PROJECT: Dexter Community Schools
New Fieldhouse Addition

RE: POST BID ADDENDUM 3

Date	April 23, 2026
Project Name	Dexter Community Schools – Dexter High School Field House
TMP Project No(s).	25026E
Design Release	Three (3)
Addendum No.	One (1)

DRAWING NO.
C305.03

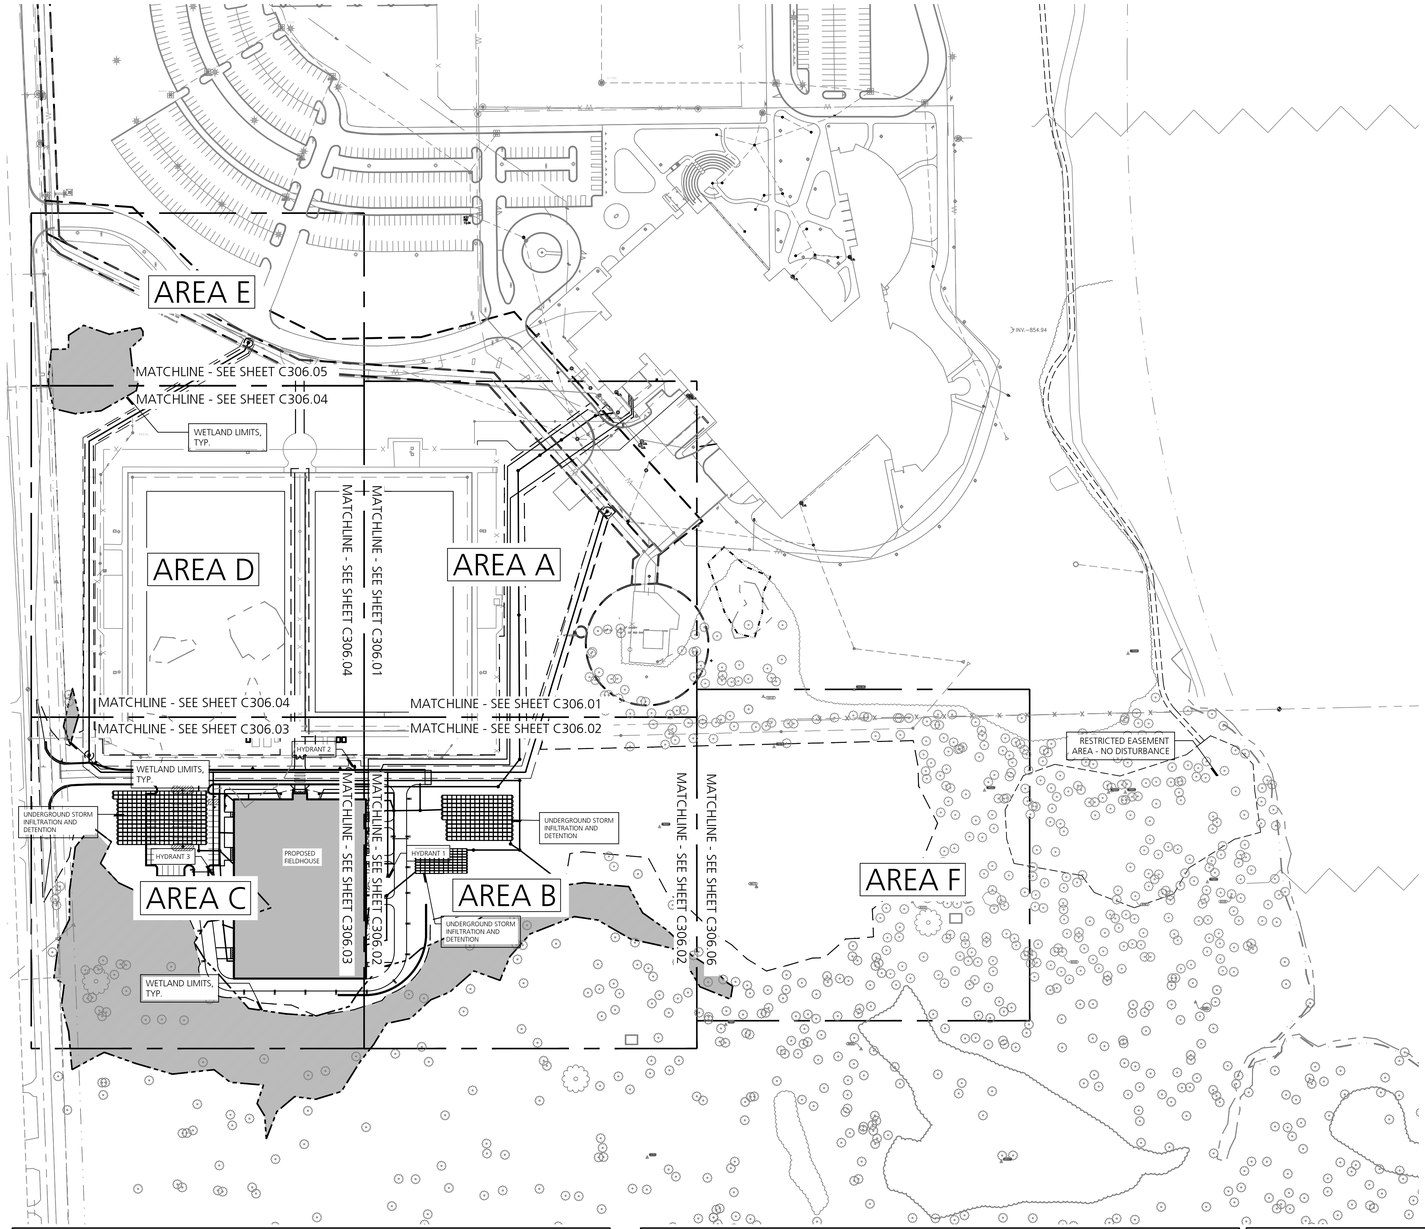
CD-5 Refer to Drawing No. C305.03 (reissued):

A. Added top of boulder wall spot elevations at south side of the building.
B. Removed boulder wall at southwest corner of the building.
C. Revised entry drive radii at Parker Road location.
D. Revised the 'Limit of Disturbance' line along the northwest corner of the wetland. The overall amount of encroachment has been reduced.
E. Revised filter fabric fence at new 'Limit of Disturbance' line adjacent to wetland.

DRAWING NO.
C306.00

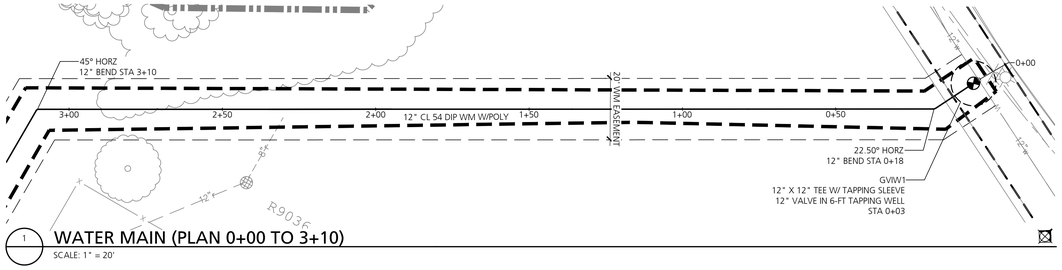
CD-6 Refer to Drawing No. C306.00 (reissued):

A. Revised elevations of various 4" and 6" downspout leads.
B. Revised rim elevations of STR CO 1, 3, 4, and 8.
C. Backflow preventers added to STR MH R2 and STR CB R4.

DRAWING NO.
C306.14

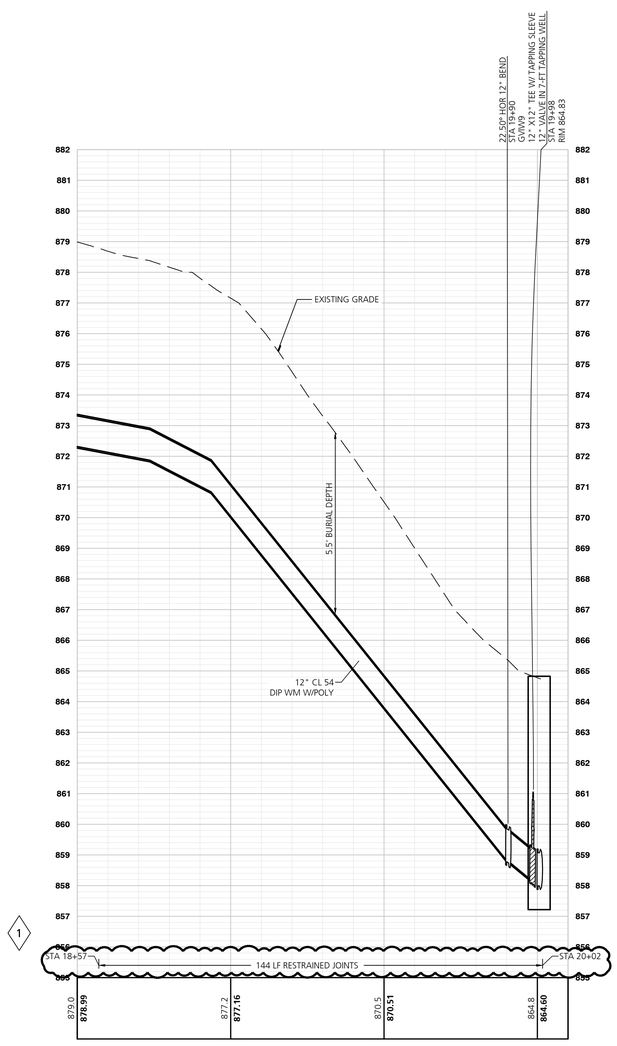
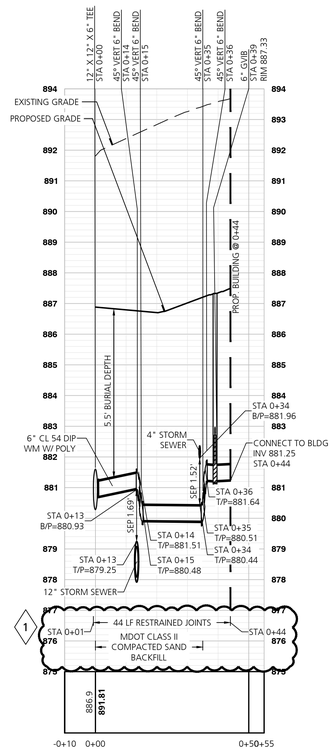
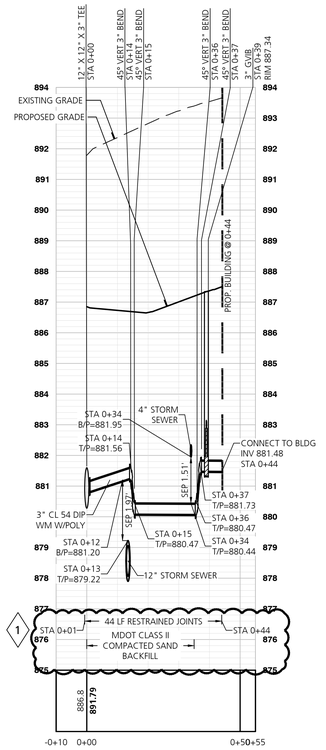
CD-11 Refer to Drawing No. C306.14 (reissued):

A. Added locations of restrained joints to profiles.
B. Added limits of sand backfill to profiles for utilities within a 1:1 influence of pavement.

DRAWING NO.
C306.30

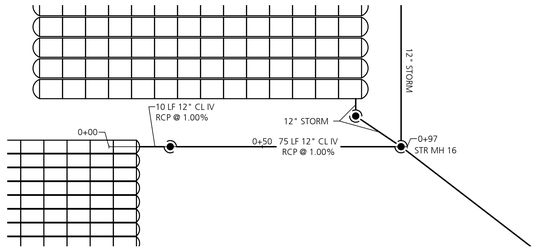
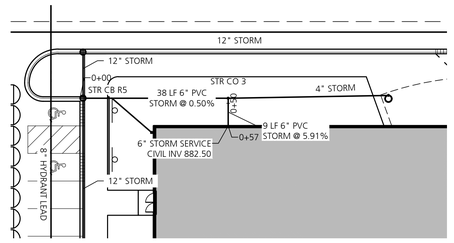
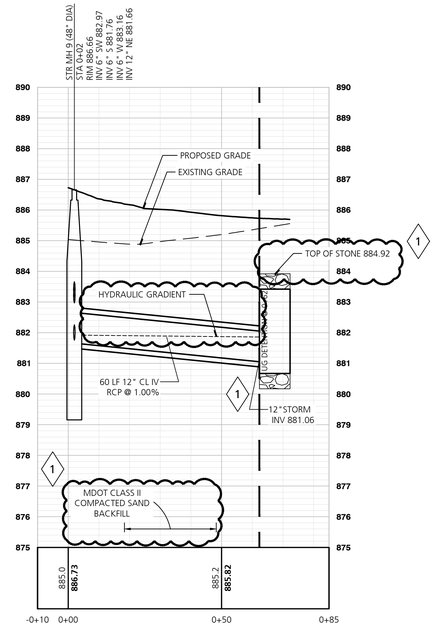
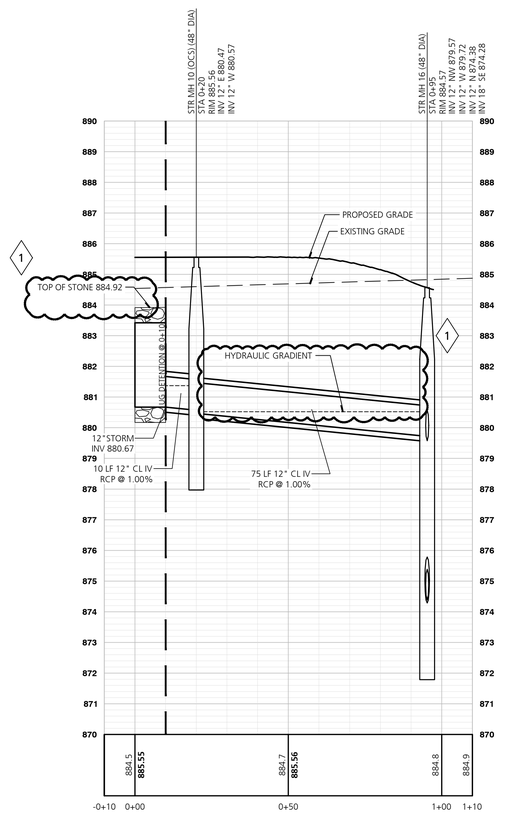
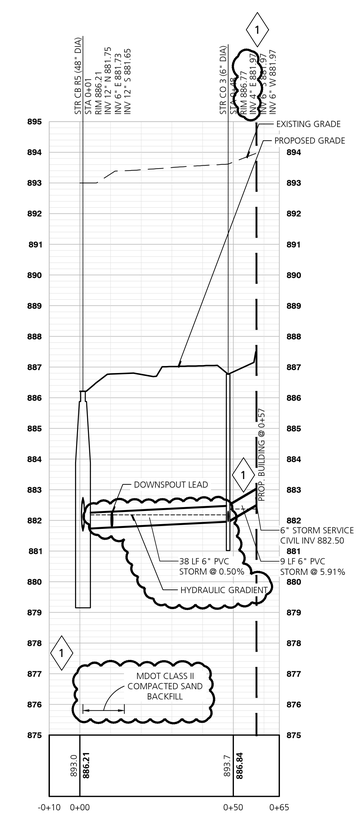
CD-15 Refer to Drawing No. C306.30 (reissued):

A. Added limits of sand backfill to profiles for utilities within a 1:1 influence of pavement.
B. Added hydraulic gradient to profiles.
C. Added top of stone elevation to profiles for UG Detention systems.
D. Revised rim elevation for STR CO 3.
E. Revised invert elevation for 4” downspout lead in STR CO 3.

DRAWING NO.
C306.31

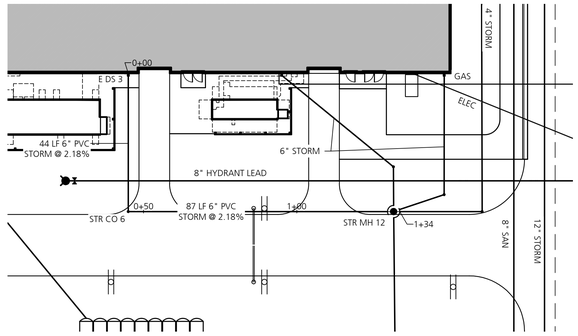
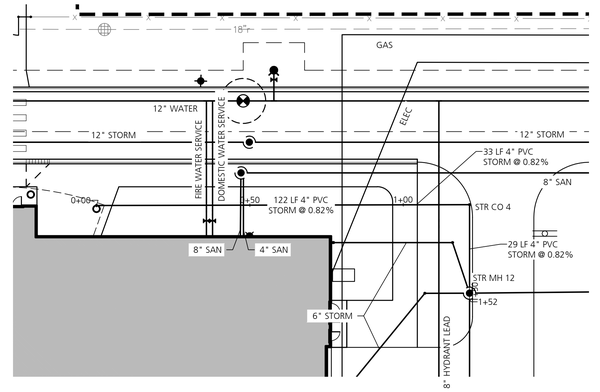
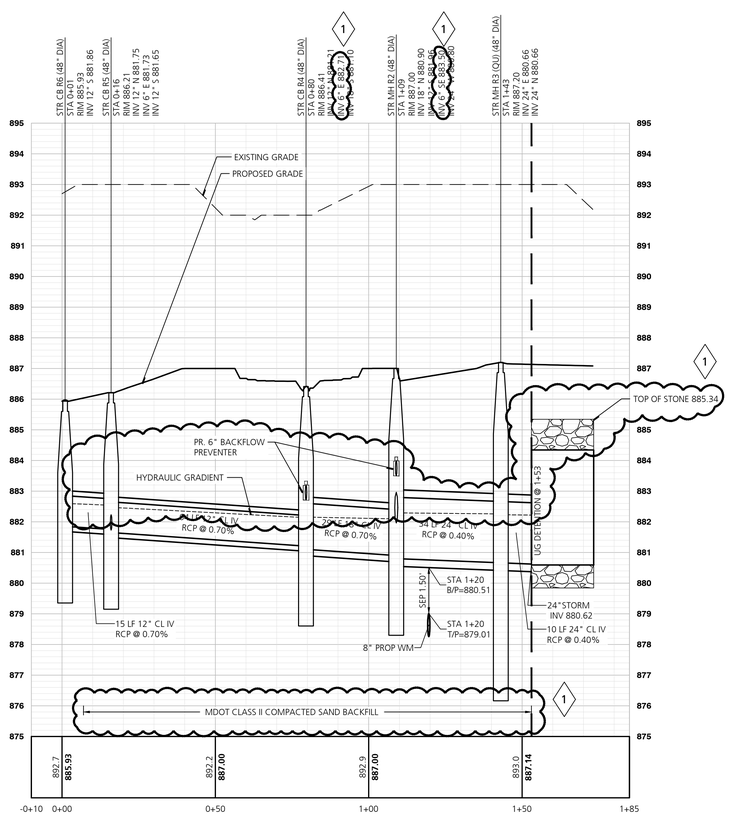
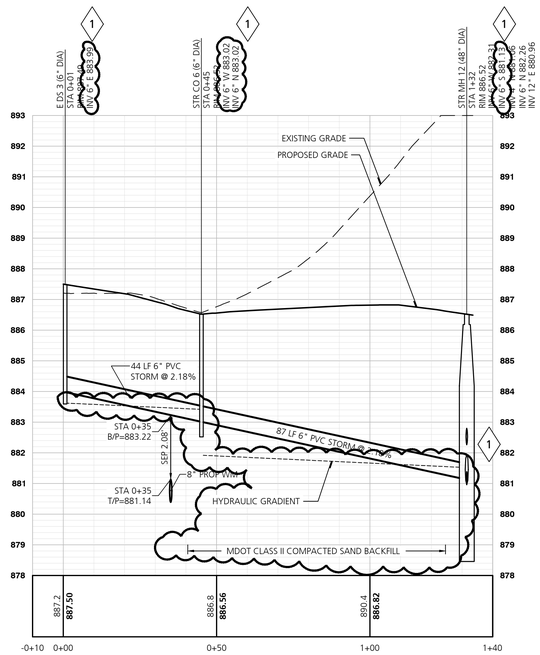
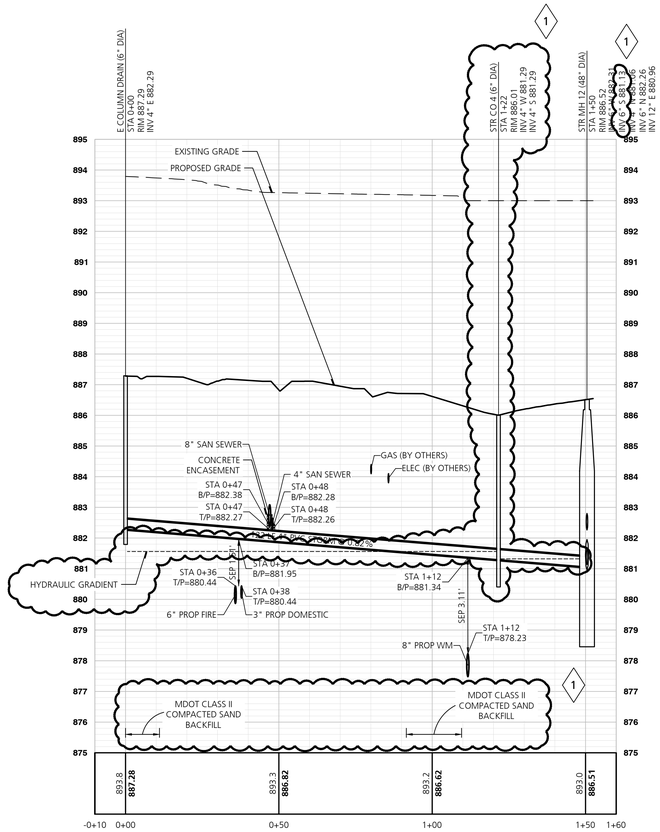
CD-16 Refer to Drawing No. C306.31 (reissued):

A. Added limits of sand backfill to profiles for utilities within a 1:1 influence of pavement.
B. Added hydraulic gradient to profiles.
C. Added top of stone elevation to profiles for UG Detention systems.
D. Revised invert elevations for various 4” and 6” downspout leads in profiles.
E. Added STR CO 4 to profile for east column lead.
F. Backflow preventers added to STR MH R2 and STR CB R4.

DRAWING NO.
C306.32

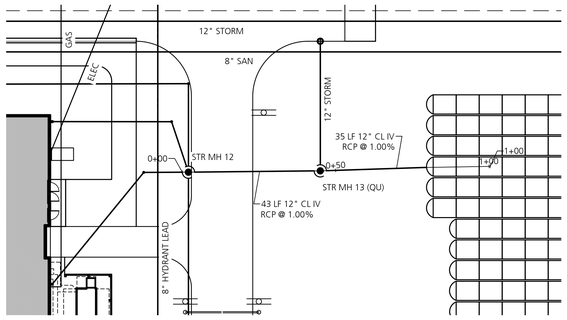
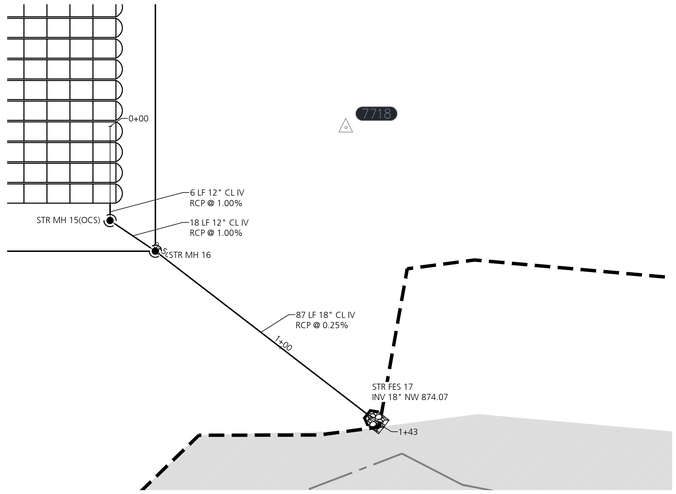
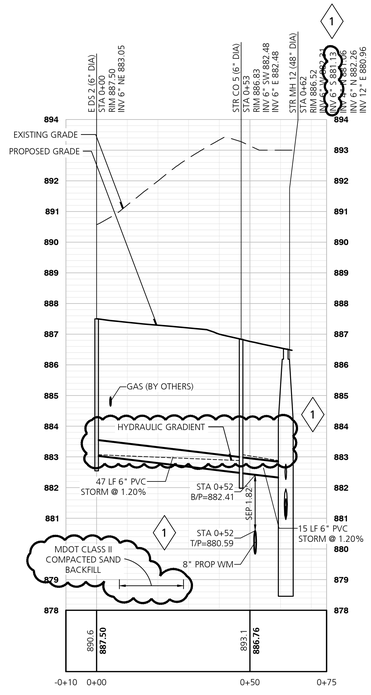
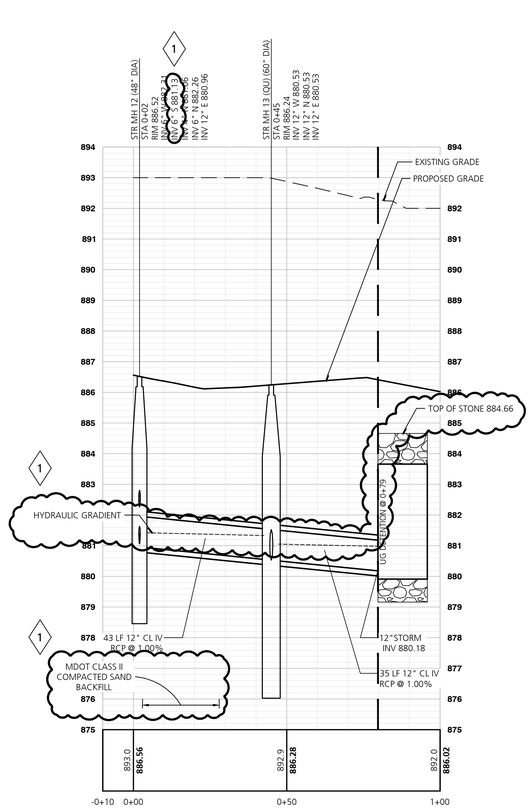
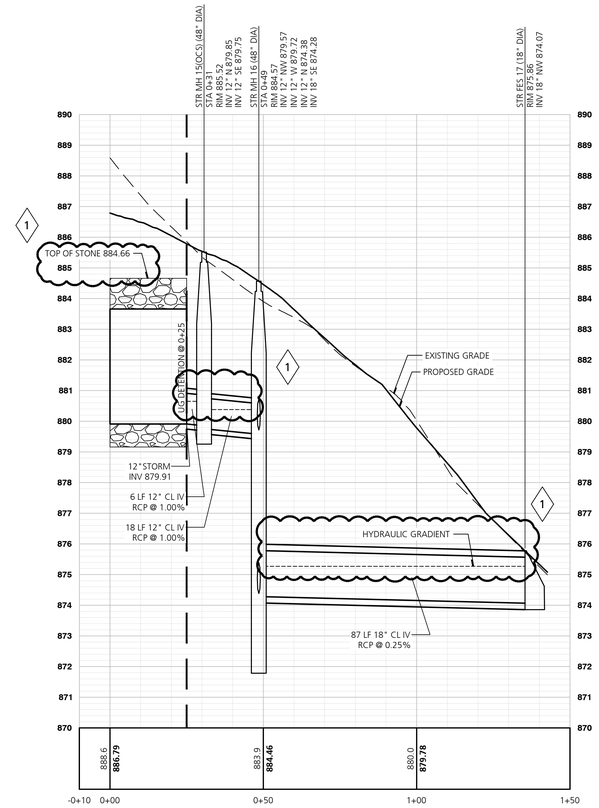
CD-17 Refer to Drawing No. C306.32 (reissued):

A. Added limits of sand backfill to profiles for utilities within a 1:1 influence of pavement.
B. Added hydraulic gradient to profiles.
C. Added top of stone elevation to profiles for UG Detention systems.
D. Revised invert elevation for 6” downspout leads in STR MH 12.

DRAWING NO.
C306.33

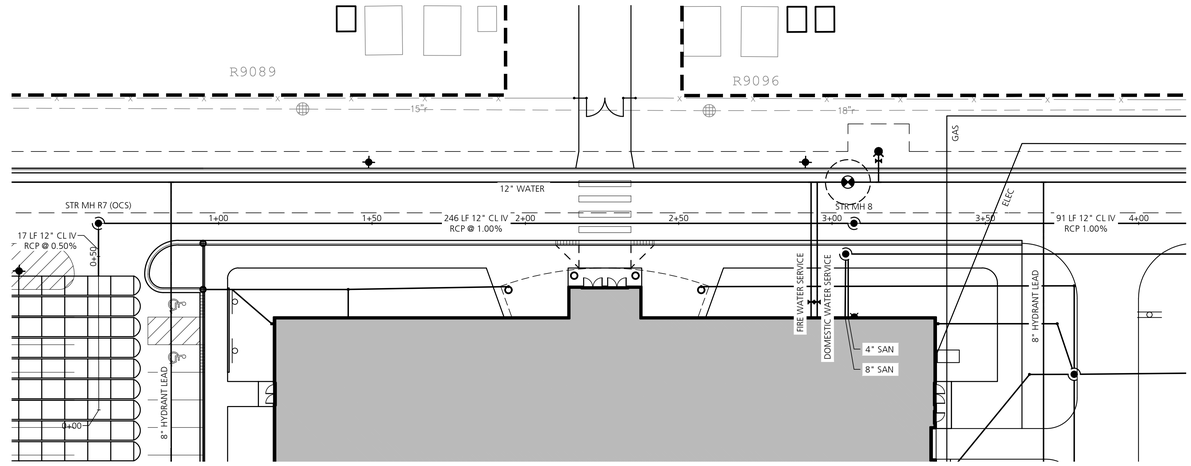
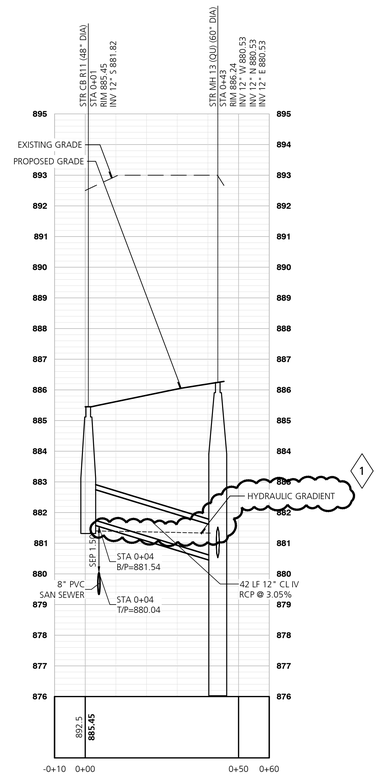
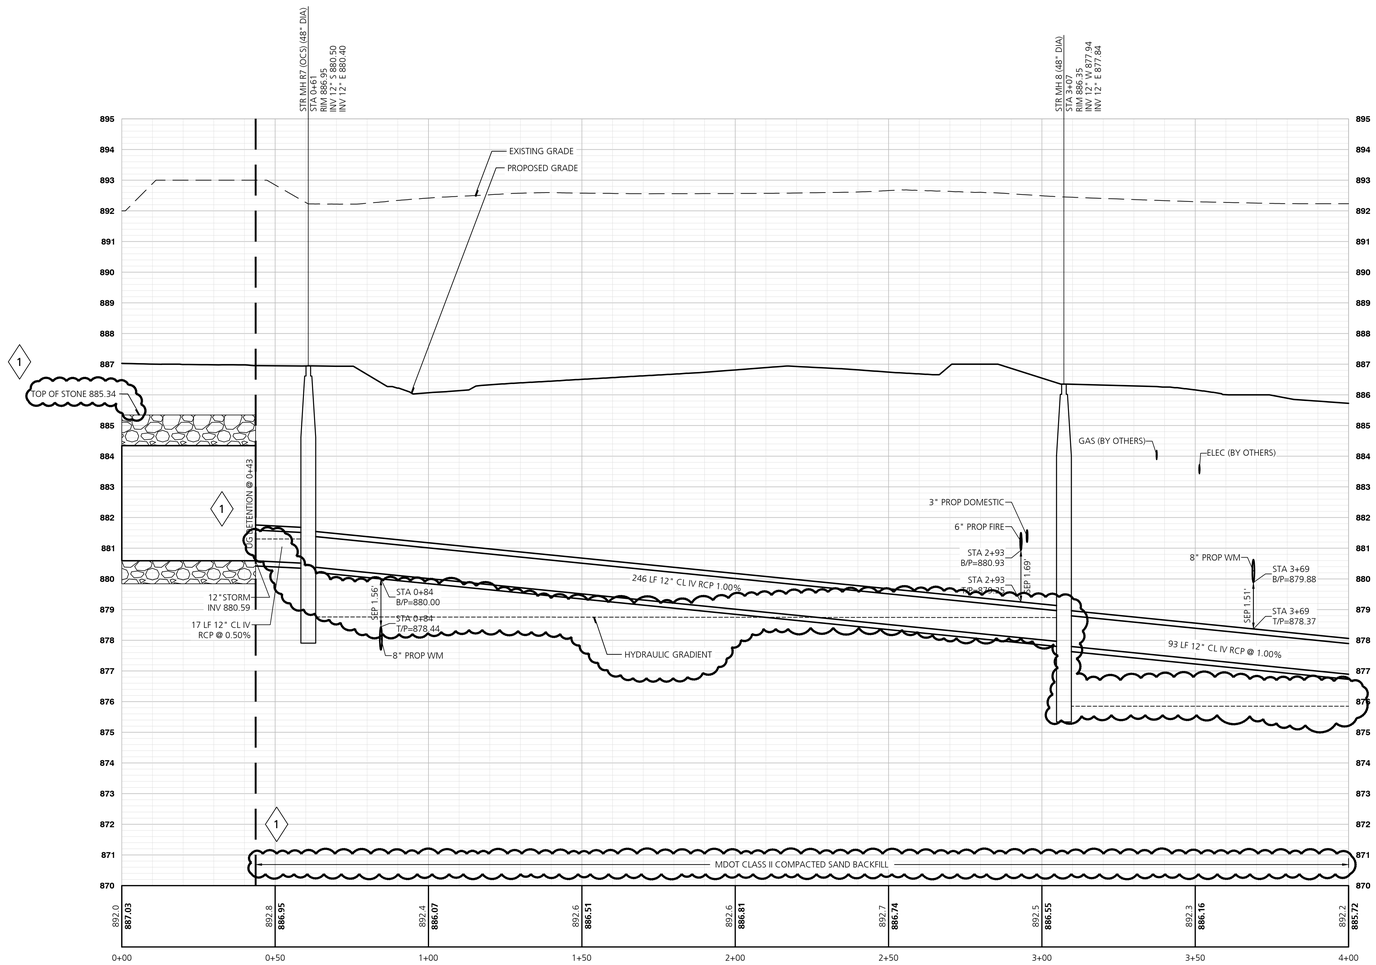
CD-18 Refer to Drawing No. C306.33 (reissued):

A. Added limits of sand backfill to profiles for utilities within a 1:1 influence of pavement.
B. Added hydraulic gradient to profiles.
C. Added top of stone elevation to profiles for UG Detention systems.

2 Standard Curb & Gutter / MDOT B3
SCALE: 1" = 1'-0"

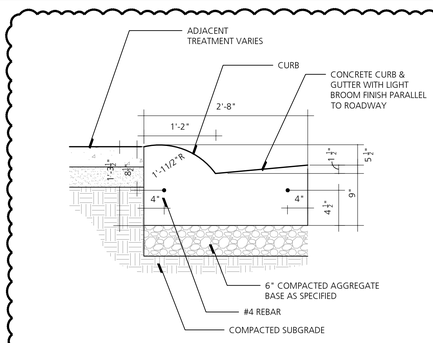
CD-21 Refer to Drawing No. C307.02 (reissued):

A. Added Backflow Preventer Detail.
B. Added Standard Curb & Gutter / MDOT B3 Detail.
